CP Rail Rogers Pass Development

Glacier National Park

Final Report of
the Environmental
Assessment Panel

August 1983

Figure 2 - Location of CP Rail Rogers Pass Development

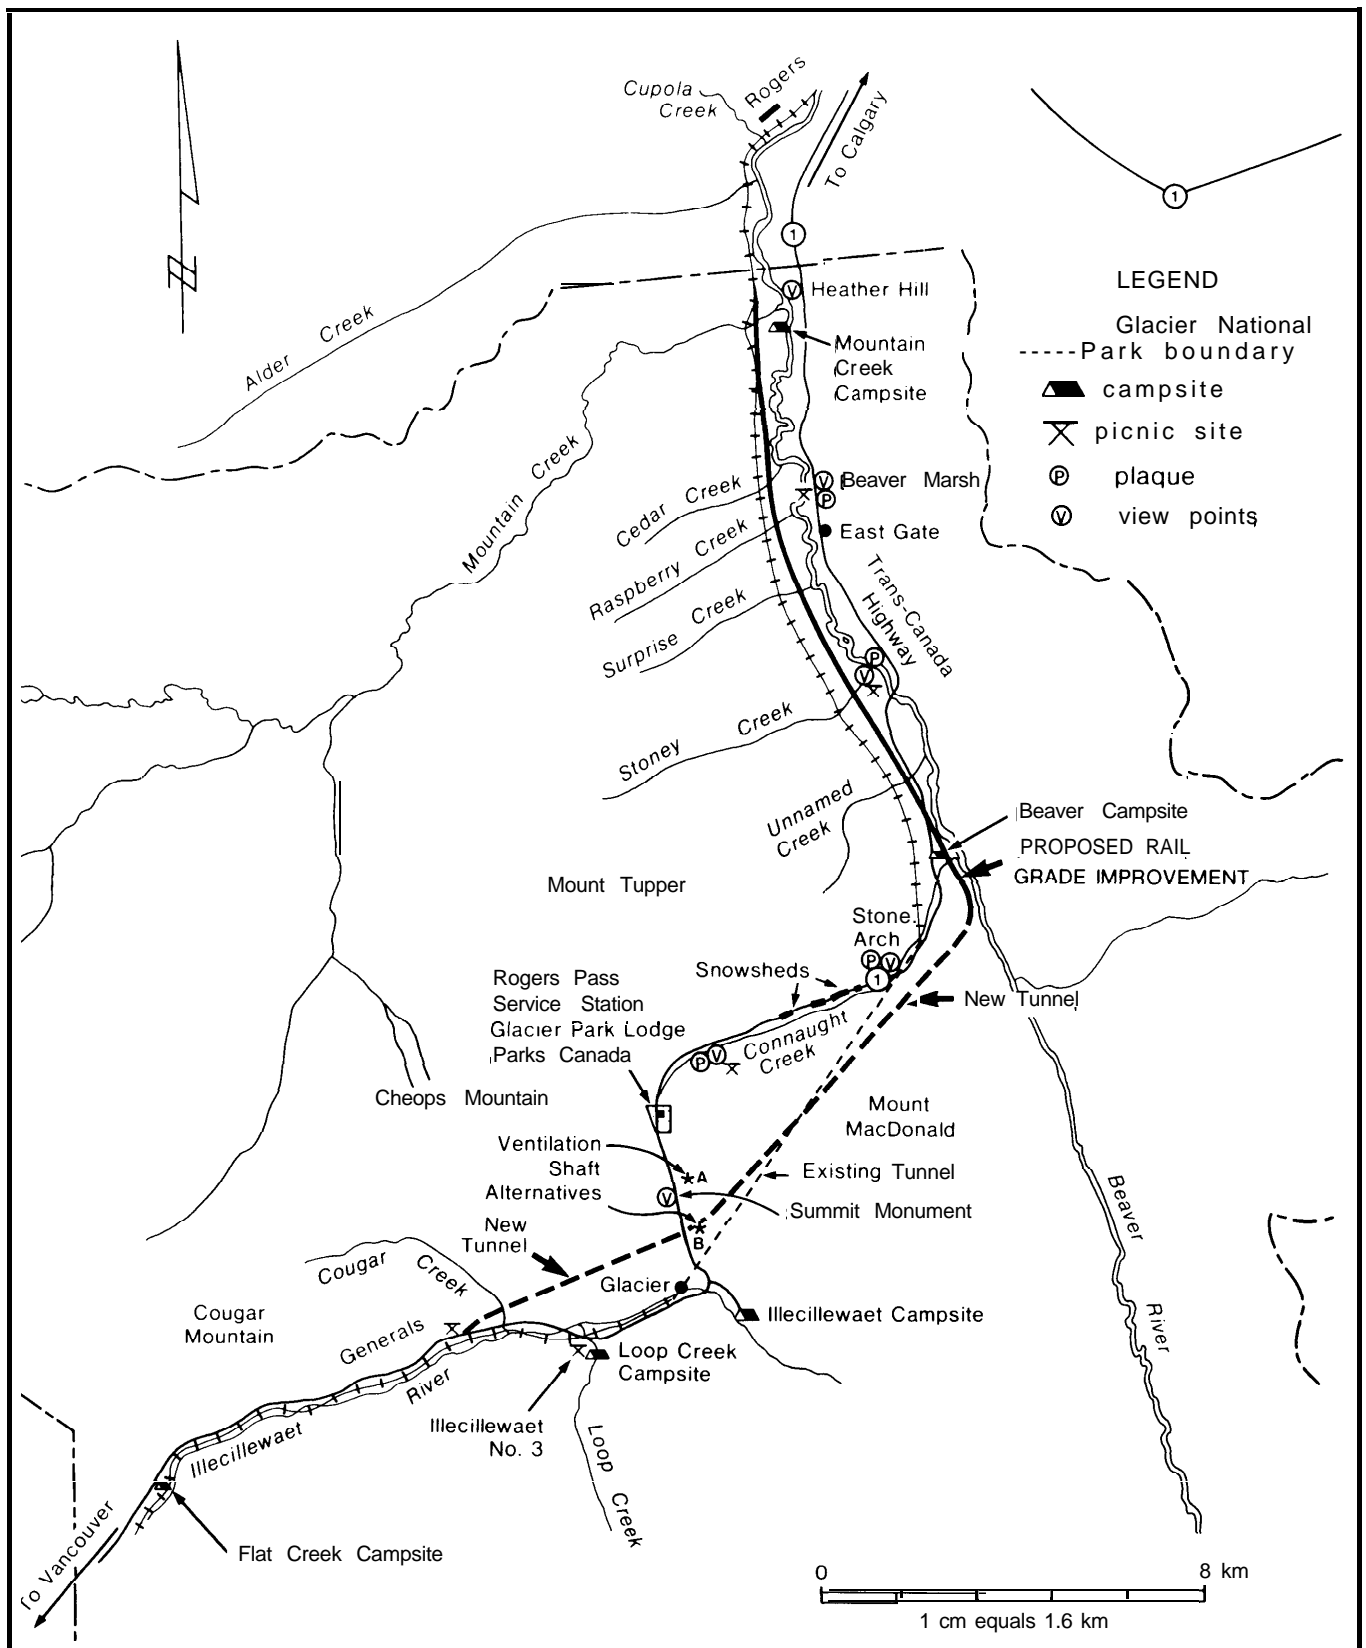
CP Rail originally proposed locating the surface structure about 430 metres from the Trans Canada Highway opposite the Rogers Pass Summit Monument (location A, Figure 2), on the face of Avalanche Mountain (Mount MacDonald). At this location, the structure would have been highly visible to the thousands of visitors who annually stop at the Summit Monument to view the beauty of the area. Concern regarding the location of the proposed siting led CP Rail to examine another area, approximately 900 metres to the south of location A, but closer to the Trans Canada Highway (location B, Figure 2). CP Rail stressed that this alternative would have less visual impact than the original proposal, since it would be further from the Monument and located in a treed area.

In the Panel's preliminary report, it was recommended that further study should be carried out on the alternative location for the ventilation shaft. The Panel required

information on the visual impact, noise, disposal of excavated material, avalanche protection requirements, structure details and the location and nature of the access to the ventilation shaft.

Figure 3 - Plan View of Camp Locations

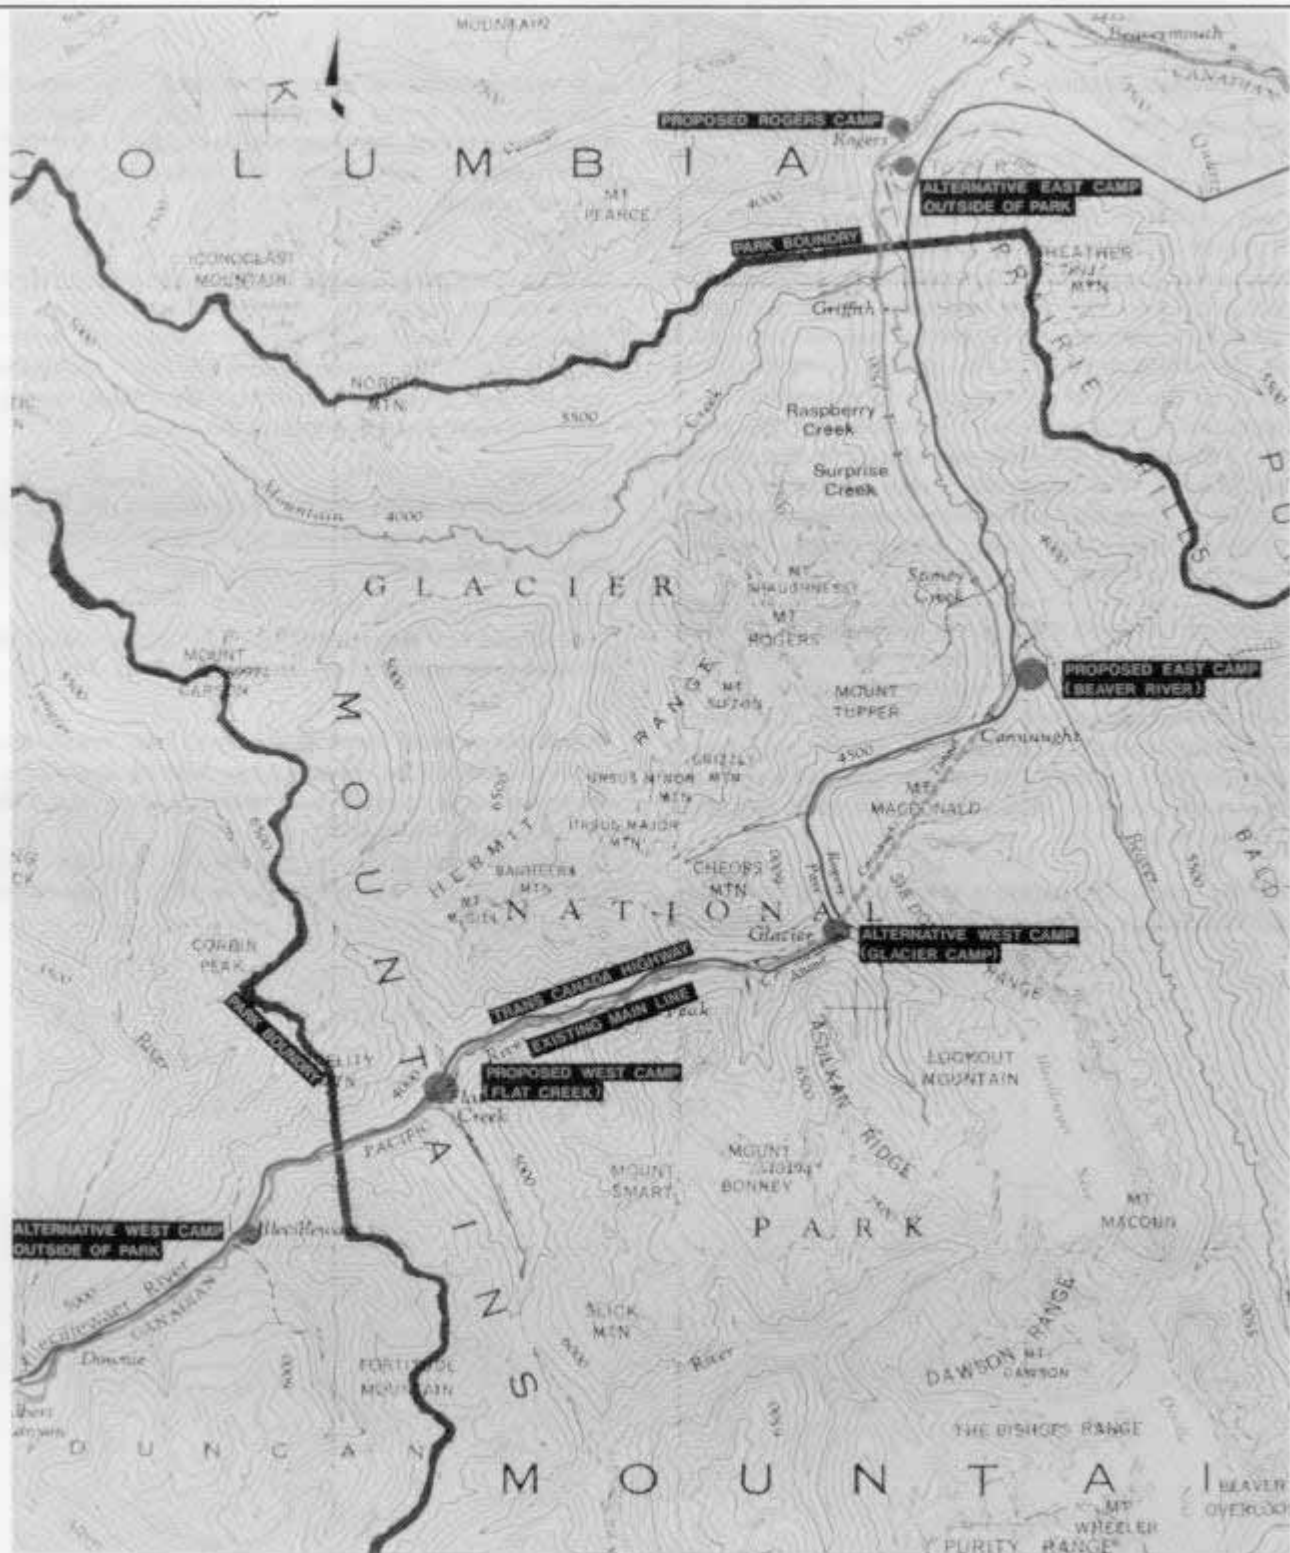
CP Rail's original proposal called for three work camps for 1982: two within the Park, Beaver and Flat Creek, and one outside the Park at Rogers (see Figure 3). Flat

Creek and Beaver were each to contain approximately 30 people in 1982. After considering the information presented at the 1982 public meetings, the Panel concluded that the Beaver work camp should be permitted for portal construction crews, subject to prior provision of adequate precautions and approved design and subject to a careful monitoring program. The Panel stated that if monitoring indicated satisfactory results at Beaver, the Flat Creek camp could be installed as early as Fall 1982. If problems had been encountered at the Beaver camp, the Panel would have required further information on sites outside the Park in order to reach a final conclusion on work camp locations for the duration of the project.

Figure 4 - The Ventilation Shaft Structure

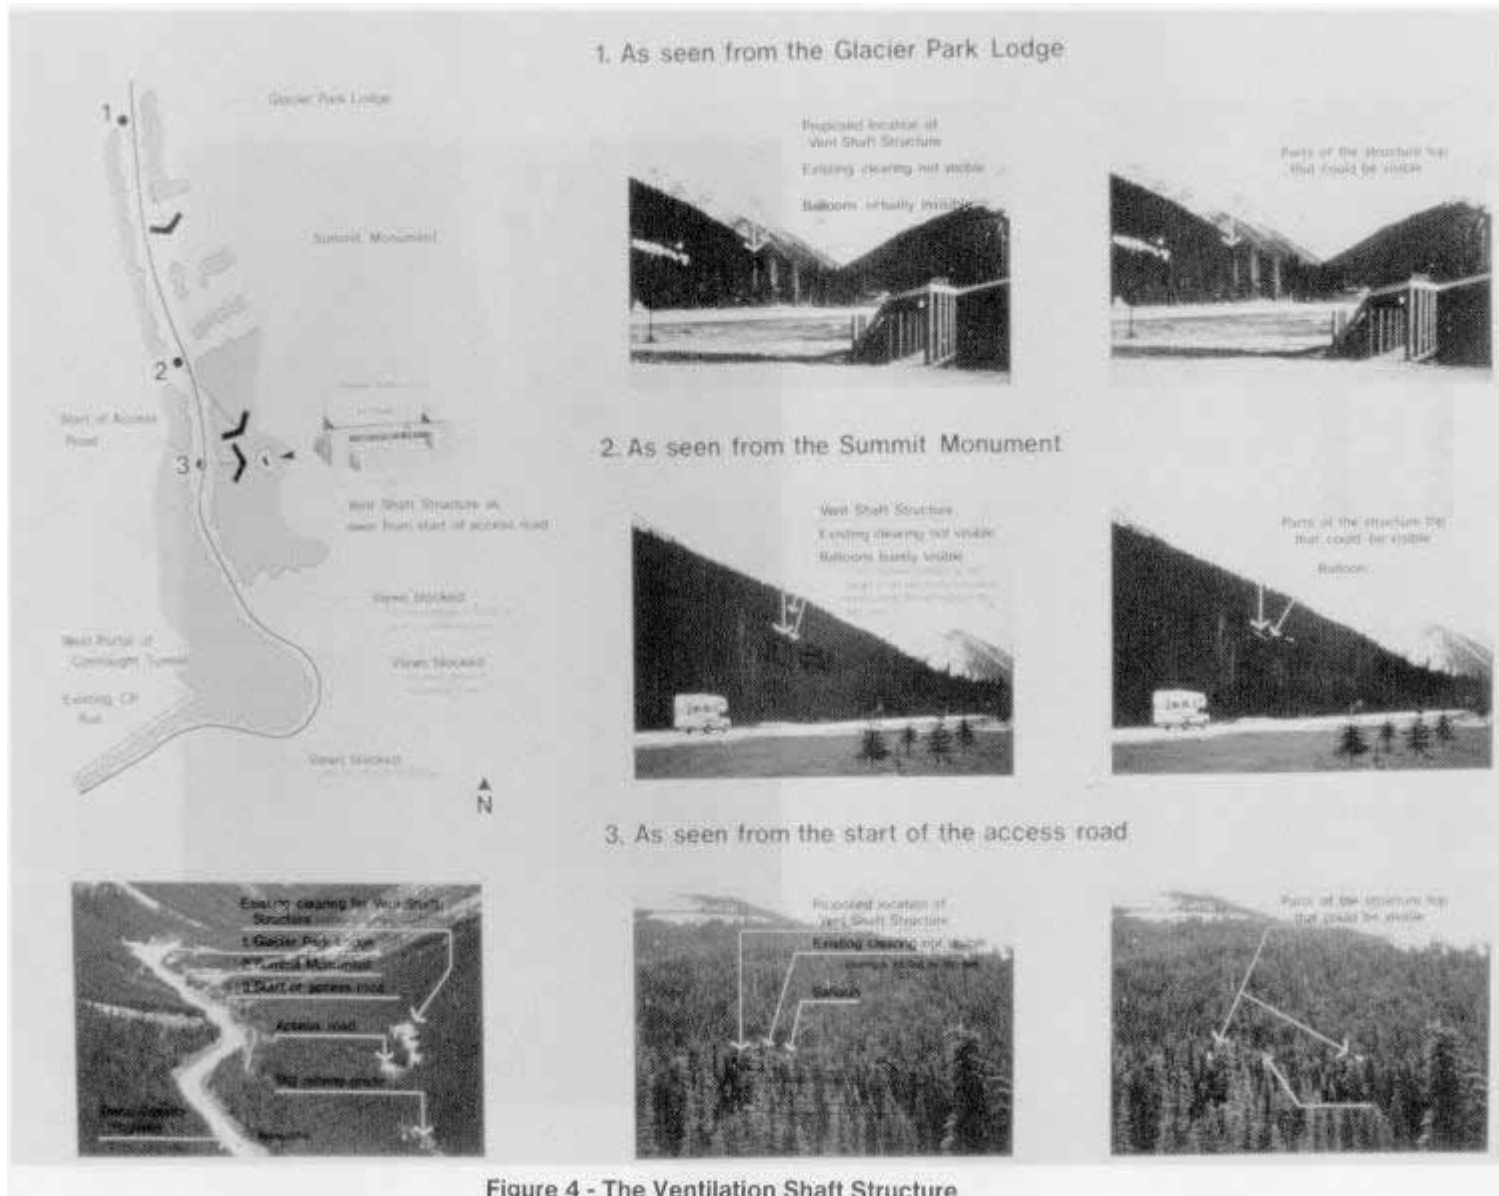
In the Panel's preliminary report CP Rail was requested to demonstrate its claim that the surface structure could be completely screened from the highway, the Summit Monument and Glacier Park Lodge. In CP Rail's subsequent release of its visual impact assessment report (March, 1983), only brief mention was made of the potential visual impacts of the structure. In early May, the Panel again requested the information from CP Rail who responded by providing the results of a consultant's study. The study consisted of observing red helium-filled weather balloons that were fixed at measured heights above the ground surface in the existing clearing for the structure. Ground surveys of vegetation heights were also conducted to verify the results. The study concluded that the structure will be virtually

It was noted that the present tree cover is essential to ensuring that the visual impact at the new location B is minimized. During the meetings the Panel heard concerns regarding deforestation due to natural causes. Should this occur, the structure would be highly visible from the Summit Monument, the Lodge, and the Trans Canada Highway.

The Panel concluded that the visual impact of the new location B would be acceptable provided that clearing was limited to approximately the present area. If necessary, new trees should be planted to maintain continuity of the visual screen in the future.

In view of its potential visibility within a National Park setting, the building must be designed with sensitive architectural treatment and a careful selection of exterior materials. The Panel recommends that the location of the ventilation structure proposed by CP Rail is acceptable provided detailed plans and specifications are submitted to Parks Canada for approval. Parks Canada should obtain architectural services to assist with its review.

At the public meetings held in June, 1983, the Panel's technical expert generally agreed with CP Rail's acoustical evaluation. He stated that if the objectives noted by CP Rail's consultant could be achieved, ventilation shaft noise would not be a problem at the Summit Monument or Glacier Park Lodge. Under worst conditions, in some directions from the vent, and at certain times, noise would be audible up to 600 metres away. It was recognized that the design was conservative and that further mitigation was possible if necessary. Although noise from the east portal was a lesser concern, it is proposed that the same criteria apply.

The Panel concludes that although there will be a residual noise impact, the area involved is limited and not of special significance. CP Rail's proposal for noise level reduction is therefore acceptable, but monitoring should be carried out during operation to ensure that the design criteria have been met. Further measures to minimize impact on the environment must be taken if unacceptable conditions occur.

Figure 5 - Typical Cut Slope Revegetation Plan

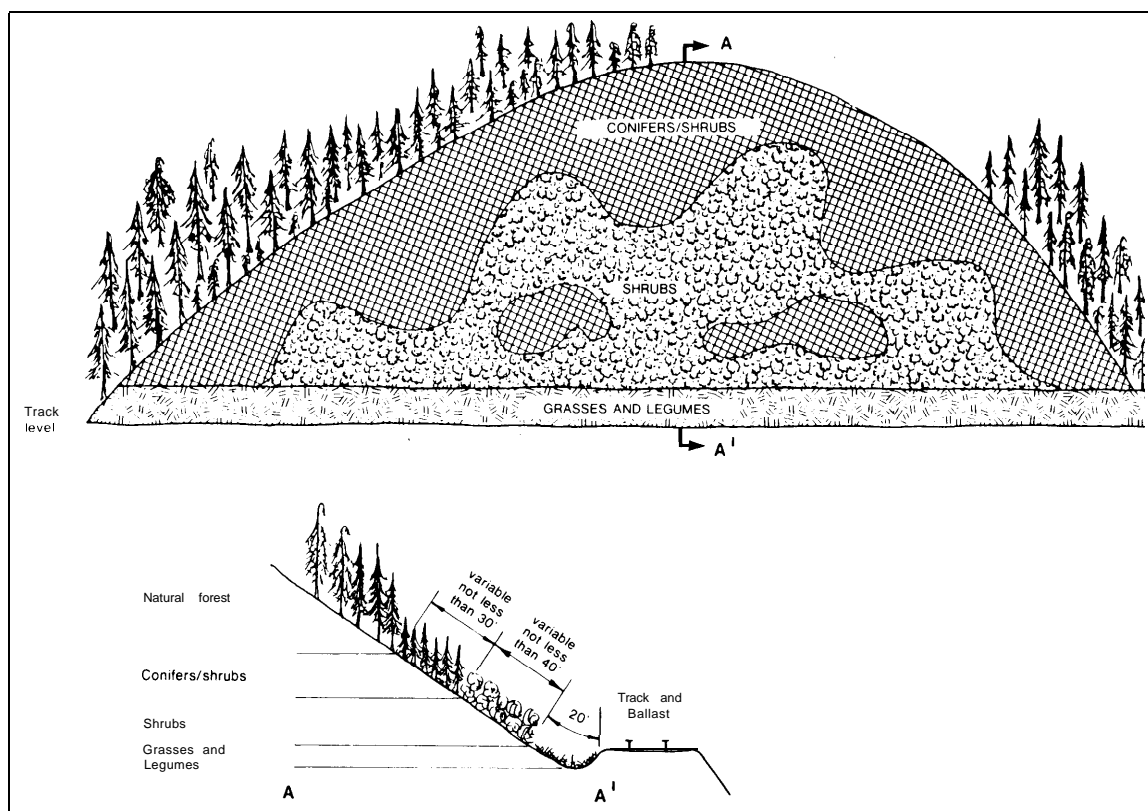
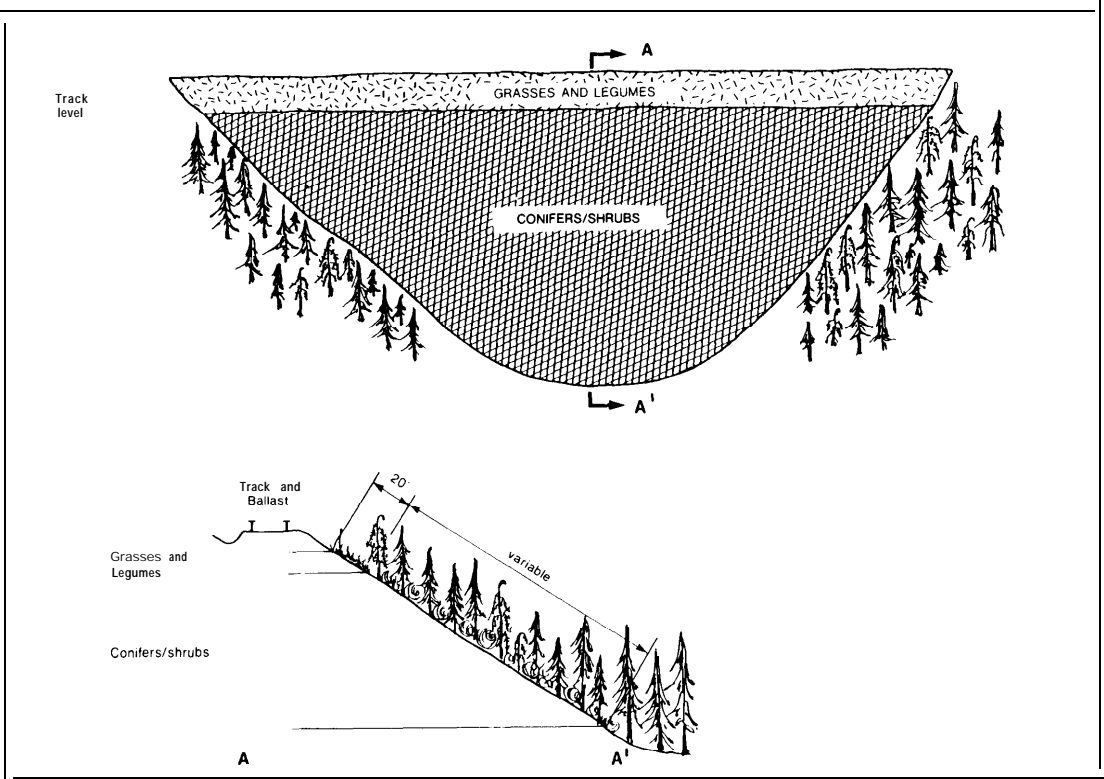
Technical experts to the Panel proposed that reclamation standards dealing with plant density, vegetative canopy cover, densities of woody species and erosion control be adopted by CP Rail and Parks Canada in the form of an agreement. Adoption of reclamation standards could provide a clear understanding of expected results. It was suggested that a reclamation bond be posted so that in the event of CP Rail defaulting on the agreement, Parks Canada would have sufficient funds to reclaim the area. CP Rail generally agreed with the proposed standards, although it rejected the idea of bonding, claiming to be governed on this matter by the Railway Act.

The difficulties of revegetating on steep slopes was discussed at the meetings. It was noted that flatter slopes increased the prospects of successful revegetation. Based on experience elsewhere, revegetation experts felt confident that, given sufficient effort, CP Rail could succeed, albeit with difficulty, in reclaiming the disturbed areas to the standards discussed. There is a need to revegetate exposed areas as soon as possible in order to reduce erosion. An area of immediate concern is the extremely steep slopes along the access road between Stoney Creek and the east portal of the short tunnel. CP Rail has plans to begin reclamation on this area during 1983.

The Panel concludes that revegetation of disturbed areas to meet stringent standards will help to mitigate the impact of the surface route. Both prompt attention and continuing effort will be necessary to ensure a successful revegetation of disturbed areas. The criteria presented at the public meetings should serve as a basis for determining the standards to be used in judging the success of revegetation (see Appendix G). Parks Canada should seek a formal undertaking from CP Rail to ensure that the stringent standards agreed to by the parties will
